DDEC® VI Troubleshooting

NUMBER: 07 DDEC VI-38 S.M. REF.: 86 ENGINE: EPA07 MBE 4000 DATE: December 2007

SUBJECT: SPN 1636/FMI 4

PUBLICATION: 6SE568

Figure 1 Intake Air Temperature Sensor

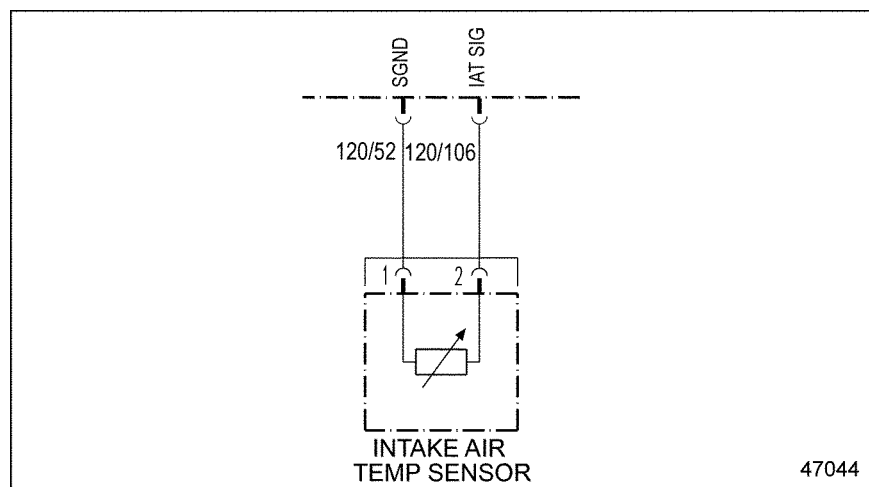
SPN 1636/FMI 4 has been changed.

This diagnosis is typically Intake Air Temperature Sensor Circuit Failed Low fault.

Repair short to ground between pin 2 of the Intake Air Temperature Sensor and pin 106 of the MCM 120-pin connector.
